# DEVELOPMENT HEARING OFFICER

**PR-2021-005684**

SD-2024-00094 – PRELIMINARY/FINAL  
PLAT IDO - 2022

REPLAT OF TRACTS E AND F INTO THREE (3) TRACTS, F1, F-2, AND F-3.

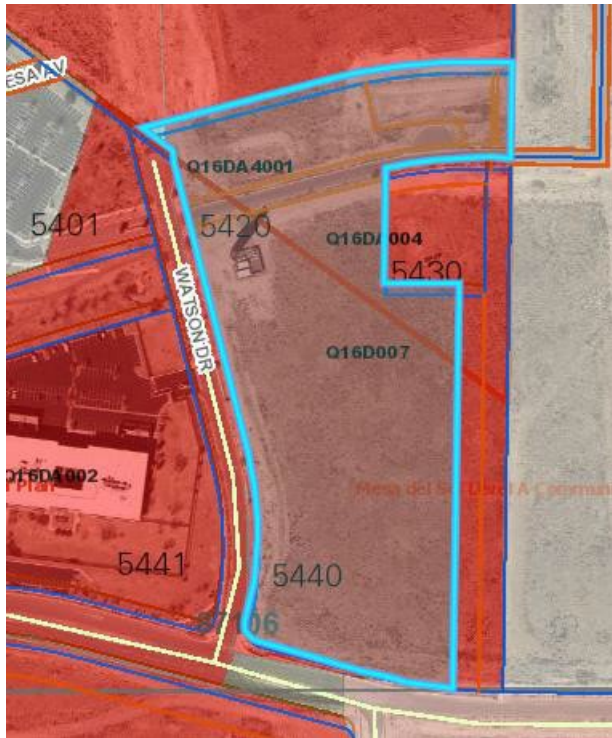
- **Please confirm the details of the proposed Preliminary/Final plat for the DHO.** Subdivision of land, two existing lots in three.

- \*Clarify the details of existing development, roadways, and easements. Will the platting action affect the easements showing in AGIS:

- Demonstrate compliance with *Section 7 of the DPM Table 7.2.29, Mesa Del Sol streetscape plan, and the Required Improvements section from 5-4(N) of the IDO.* \*Regarding Sidewalk width requirements and the landscape buffer. Clarify the construction detail and the need for an IL-infrastructure List.  
***\*Verification of standards per Transportation\****

\*Since the IL is not a part of this plat submittal, the final sign-off of the Plat will require that the Site plan be approved with an Infrastructure List for all outstanding improvements.
